6.2.3.5. Evaluation of Highway Design Alternatives

6.2.4 Bridge and Road Structure Design

Review for Cost Savings

Figure 6.17. Original and Proposed Design of Service Area

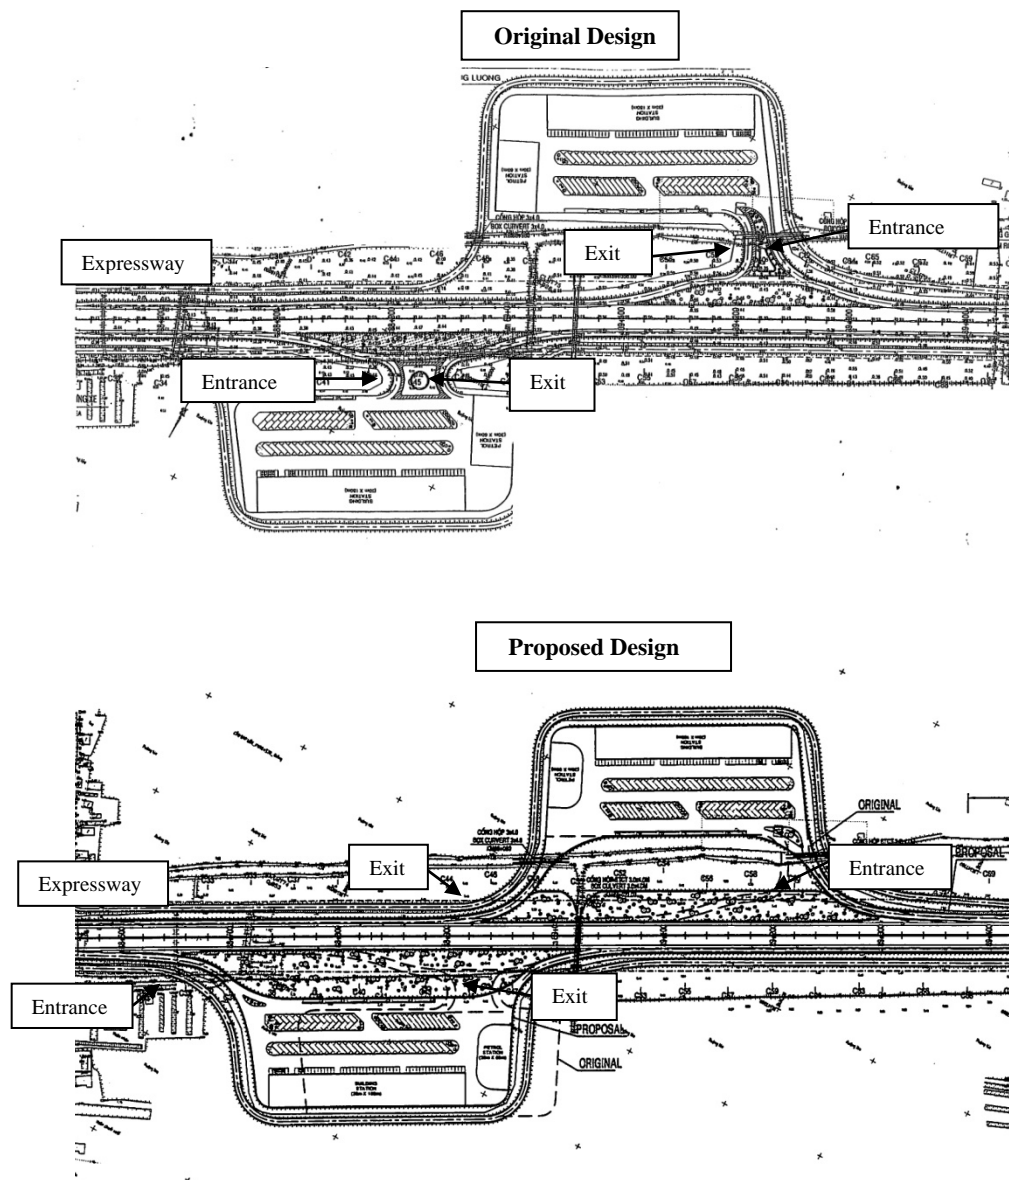
- e) Modification of position of entrance/exit of service area
- The original design of the service area poses risk because entrance to and exit from the parking lot are too close. Moreover, the traffic flows intersect in the parking lot.
 - Hence, it was proposed to shift the entrance and exit access to both ends of the parking area. Consequently, the traffic flow in the parking lot becomes simpler without any intersection.
 - Drawing showing original and proposed design of the service area is shown in Figure 6.17.

Figure 6.19. Original and Proposed Pavement Design

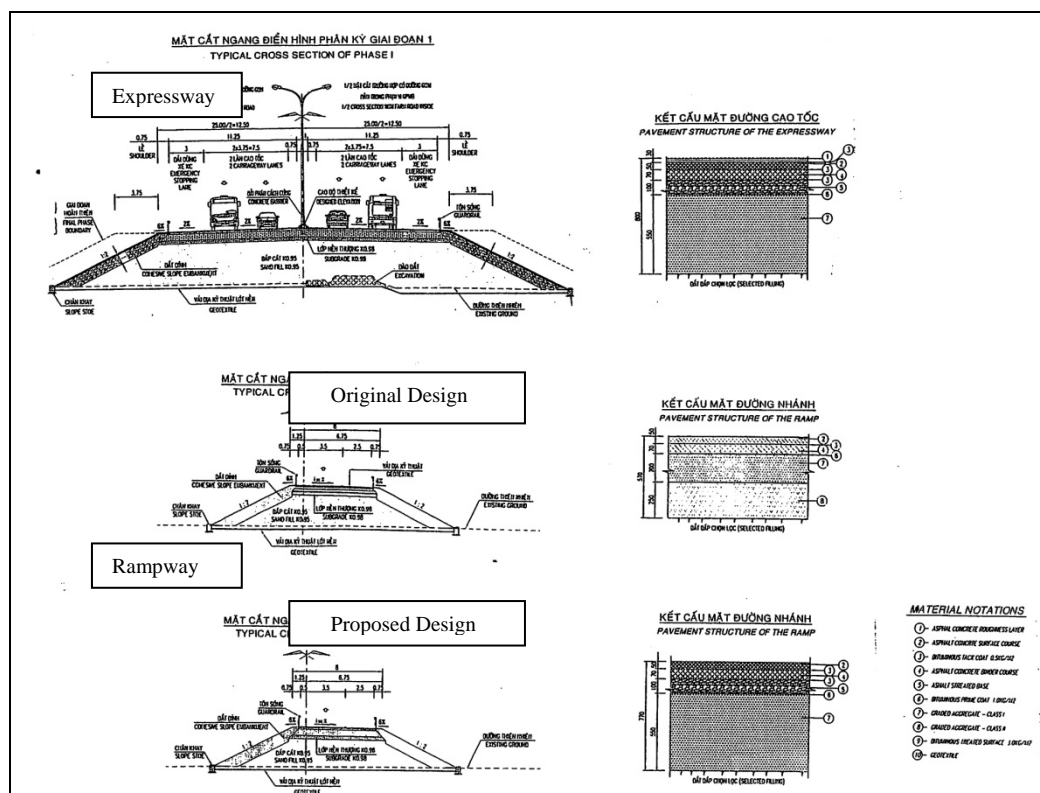
- g) Application of expressway pavement structure to rampway
- In the original design, pavement structure of rampway was designed as asphalt concrete, which is thinner than the main road pavement structure, based on traffic demand forecast for the interchange.
 - Same pavement structure as that for the main road was proposed considering that maintenance work is difficult along the narrow width of the rampway. Moreover it will become possible to lengthen the interval for regular maintenance of overlay.
 - Drawing showing original and proposed pavement design is shown **Figure 6.19**.

Figure 6.20. Proposed Traffic Safety Design

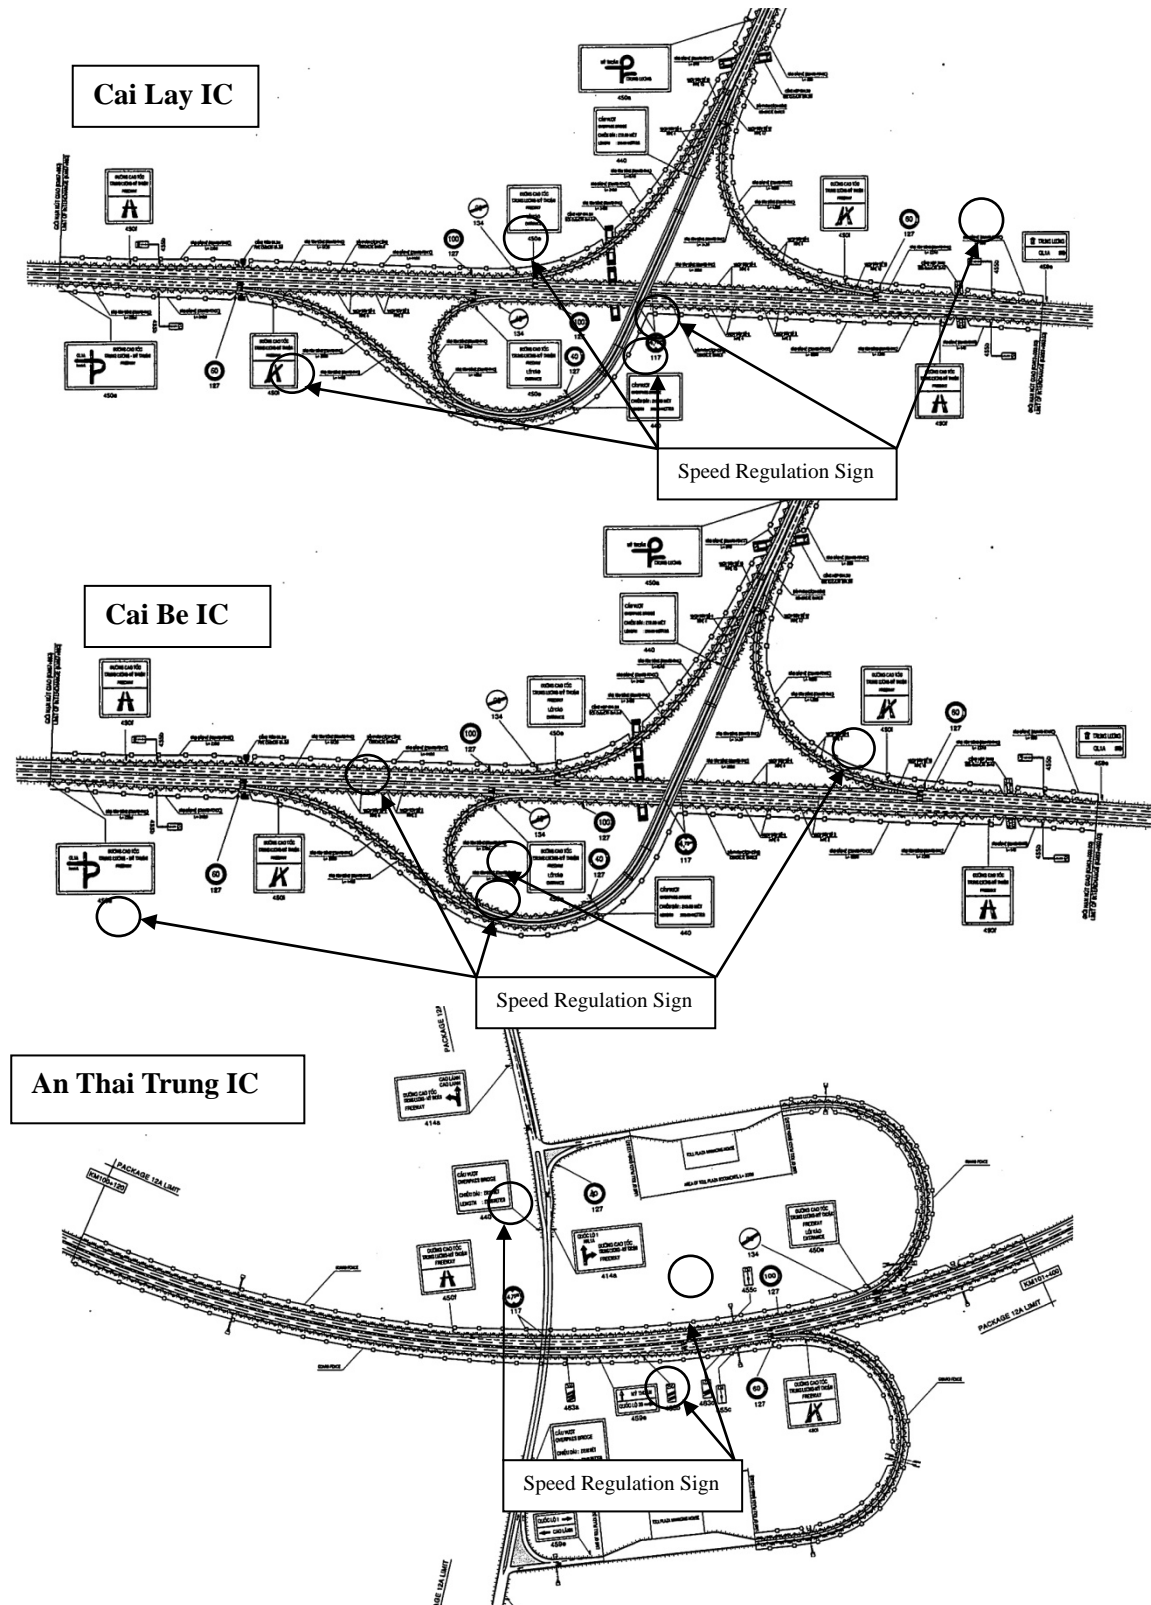
- h) Installation of speed regulation sign at IC
- In the original design, speed regulation signs were not planned at interchanges, though informatory signs were proposed.
 - It is necessary for vehicles to decelerate on the rampway because of the small horizontal curve and steep gradient of the rampway.
 - It is also necessary to slow down on the rampway to ensure safe approach to the main road where high-speed vehicles are passing.
 - Moreover, it is necessary to decelerate before the Than Cuu Nghia IC and the An Thai Trung IC as the smallest possible horizontal curve was adopted in these interchanges, within this expressway.
 - Thus, it was proposed to install speed regulation signs on the expressway and on the rampway at the interchange.
 - Drawings showing the proposed design of traffic safety on Cai Lay IC, Cai Be IC and An Thai Trung IC are shown in **Figure 6.20**.

Figure 6.21. Proposed Package Limits

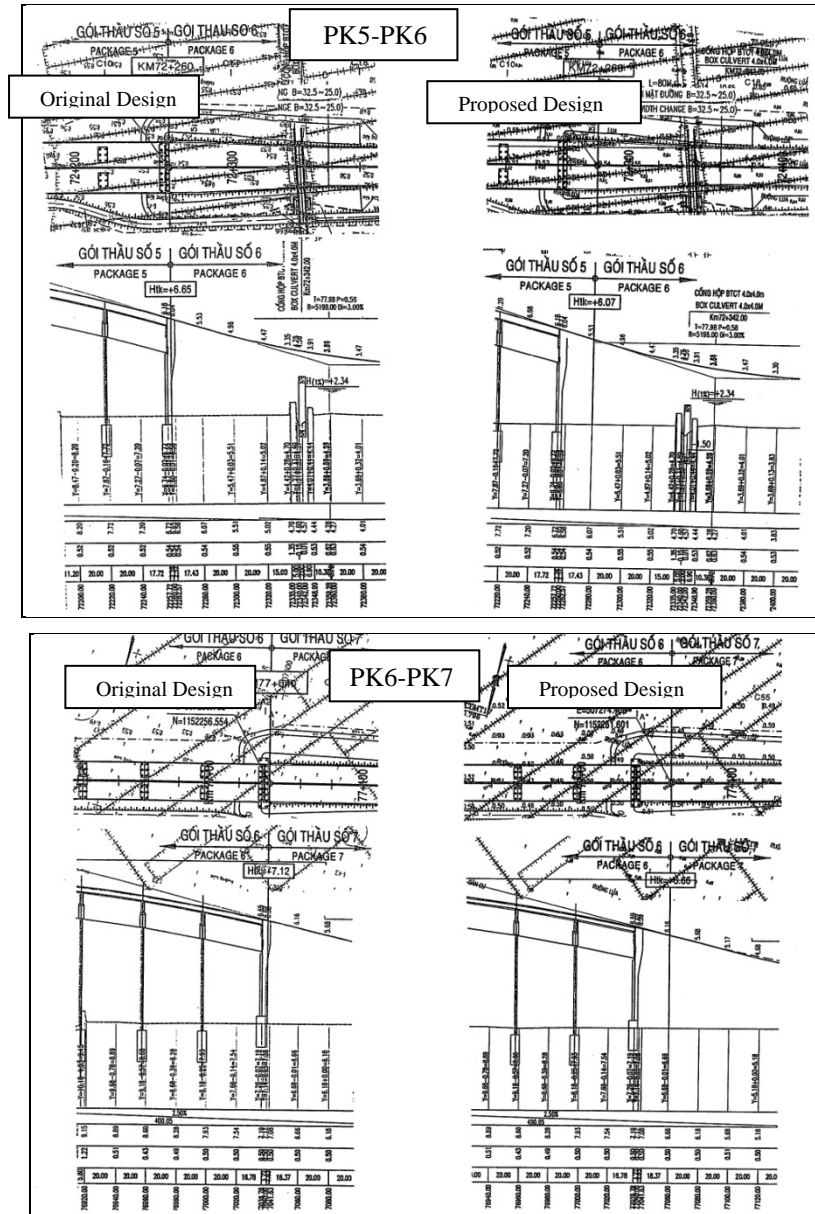
- i) Shift of package border
 - In the original design, the boundaries of packages PK5-PK6 and PK6-PK7 are located on bridge abutments. Therefore, it is difficult to separate the earthworks from the bridge

work, and divide the construction volume.

- Thus, it was proposed to shift the boundary of the said packages from the abutment of the bridge, to a point 20 m away from the abutments.
- Drawings of the original design and proposed design are shown **Figure 6.21**.

Figure 6.23. Original Design and Proposed Design of Vertical Alignment (Km 79+000 – Km 80+000)

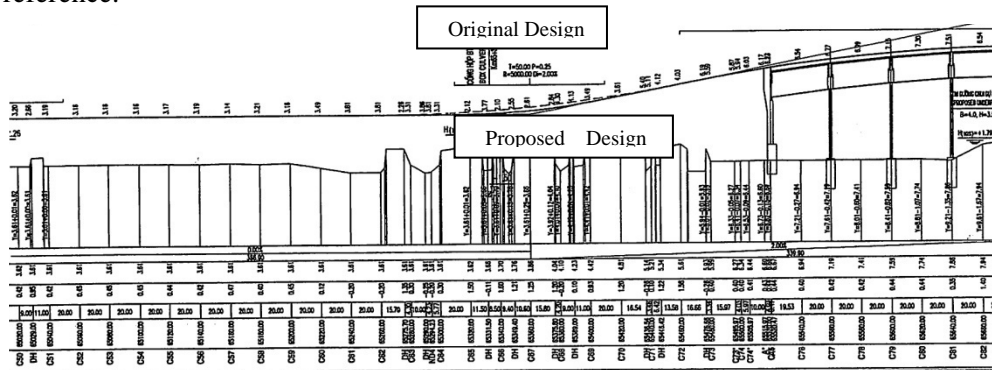
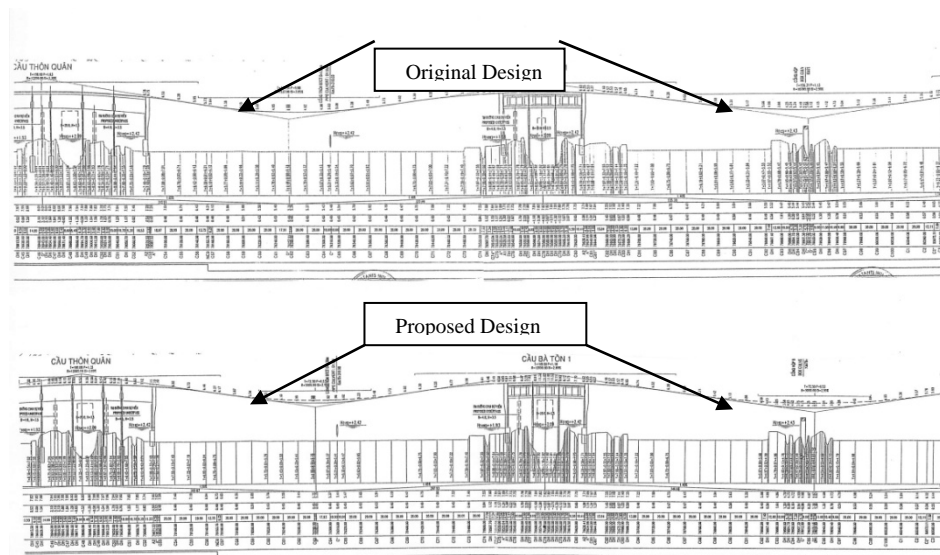
- a) Application of minimum concave vertical curve
 - In the original design, a convex vertical curve with a 12,000 m radius, which is the minimum standard value, was adopted for crest, but a concave vertical curve of 10,000 m was mainly adopted for sag.
 - Hence, it was proposed to apply the minimum standard value of concave vertical curve in

order to reduce the elevation of embankment.

- A radius of 5000 m as minimum standard for concave vertical curve was applied for the sag at embankment section, considering the minimum embankment height and the height of box culvert.
- Drawing of the section around Km 65+360 is shown in Figure 6.22 for reference.
- However, a minimum standard value of concave vertical curve was not applied for the section where the convex and the concave vertical curves are located between a short distance considering the continuity and the visibility of the alignment.
- Drawing of the section from Km 79+000 to Km 80+000 is shown in Figure 6.23 for reference.

Figure 6.25. Grade Separation Between Expressway and Local Road

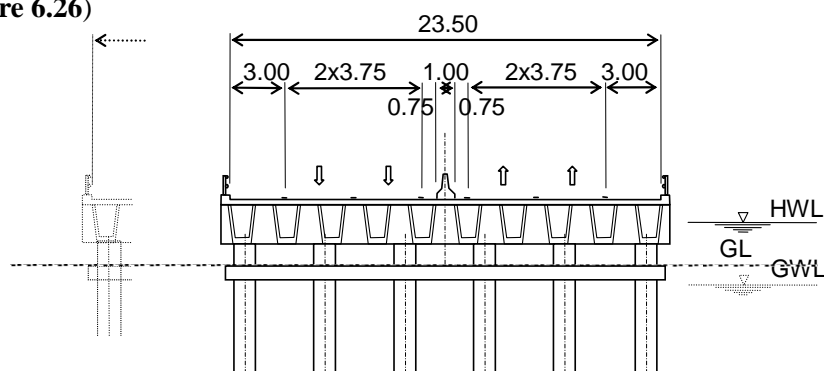
However, upon review of Dwg II-3.5 Flyover No.4 (Km 59+260), it was advised to change the grade separation method in the opposite manner wherein the expressway will pass over the local road. This was realized at this location since the ground condition is not so soft and thus, higher embankment can be constructed instead of a flyover bridge. This will cause significant cost savings. The local road can therefore pass under the expressway through a 10 m wide box culvert with a minimum cost. (See Figure 6.25)

The clearance and embankment height of local road shown in Figure 6.25 above are for reference only, and are to be confirmed with the local government.

Result of the study: Change the configuration to allow the expressway to pass over the local road at this location.

D/D Consultants revealed that the design of the expressway above the local road is more costly because the bridge becomes wider under this configuration. After studying this advice, it was also found possible to reduce cost of grade separation method at this location. However, it should be noted that the construction cost may increase depending on the range and method of soft ground treatment such as vacuum consolidation method (VCM) for high embankment section where a box culvert is placed. In addition, according to the D/D Consultants, local roads are planned to be widened in the future, and Tien Giang Province Peoples Committee already agreed to the flyover plan. These issues should be taken into consideration to judge whether this proposal should be adopted or not.

Figure 6.36. Cross-Section of Constant Depth Cantilever Segmental Box Girder Bridge

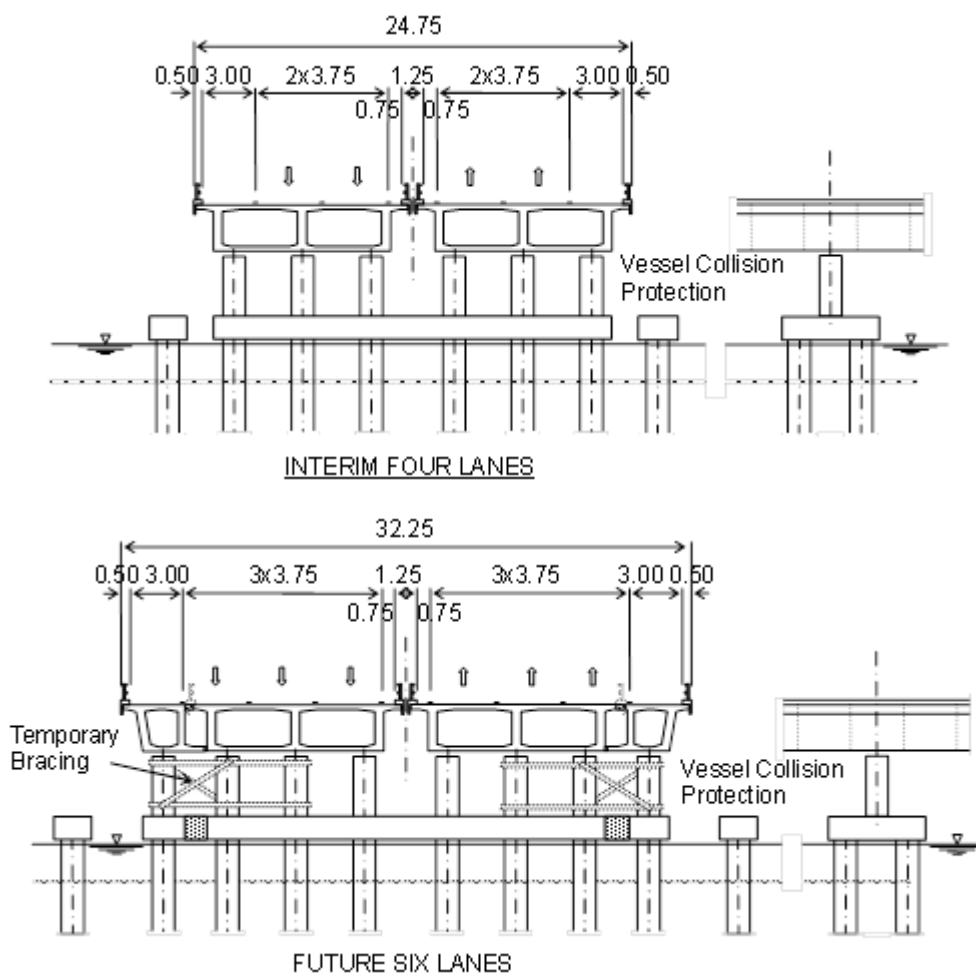
It is also advised that widening of cantilever box girder bridges is technically possible through careful preparation of design. Therefore, the bridge should be designed with only four lanes in the initial stage to save initial construction cost. (See **Figure 6.36**)

Toward the design of this constant depth cantilever segmental box girder, it is suggested to consider the following parameters:

- Girder height may be around 2.6 m based on a span-to-depth ratio of 23.
- Superstructure is separated into inbound and outbound lanes to avoid heavy girder segment in case the whole width is completed.
- For widening from four to six lanes in the future, a small one-cell box girder will be erected on either side of the existing bridge using cantilever method, similar to the initial construction stage. The widened section will be initially independent from the existing structure. Then, the existing and new bridge components will be attached together; firstly, the pilecaps and subsequently the box girder and deck slab. As shown in **Figure 6.36**, an additional pier will be laterally flexible being supported by a single row piles during the new girder erection work. Therefore, it needs to be connected temporarily to the existing

Result of the study: Variable depth box girder will be altered to a constant depth box girder as suggested.

The constant depth box girder will be employed to pass over the 50 m wide navigation clearance. Even if a cantilever box girder is adopted, it is proposed that the design be in proportion to four lanes to save initial construction cost.

Figure 6.37. Recommended Bridge Widening Method

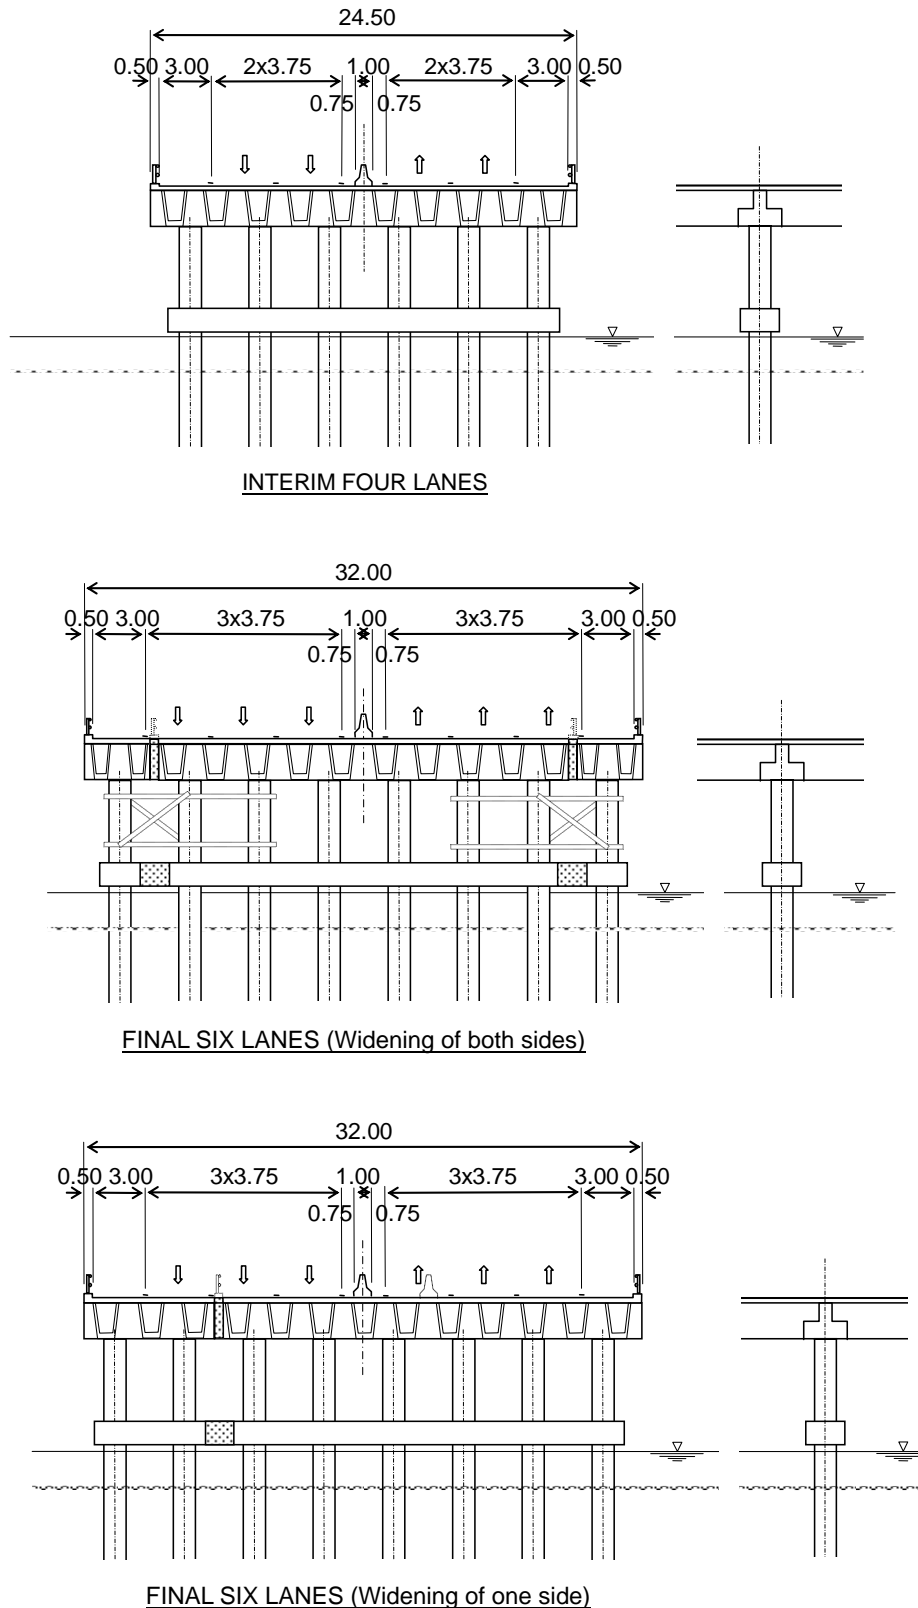
However, it is advised to design all the bridge components just for four lanes at the initial stage to save initial construction cost. The structural engineer of the JICA Survey Team has the opinion that the widening of bridge, both of pile and superstructure components is technically not so difficult if design is prepared taking into account the future widening. Symmetrical widening can maintain the road center at the same position after being widened. However, it requires repeating widening construction twice on either side of the existing bridge. It will also need temporary bracing to hold the narrow widening structure of 3.75 m width. It is noted that one-sided widening is economical for one time widening construction; however, the road center will shift after being widened. Consequently, the approach road needs to be adjusted to match the road centerline and that of the bridge. (See **Figure 6.37**)

Result of the study: Bridges will be designed for four lanes only for both the pile and superstructure components during the initial construction.

D/D consultant is concerned about the additional piling work adjacent to the existing bridge structure when constructing the bridge widening. This is his reason for designing the pile components to support the future six lanes even in the initial four lanes stage. However, the Bridge Engineer of the JICA Survey Team explained that adjacent pile construction will not be a construction problem because bored pile is widely acknowledged as the safest piling method for constructing adjacent to the existing structure. Adjacent bored piling work is often observed being adopted for building construction sites also in HCMC.
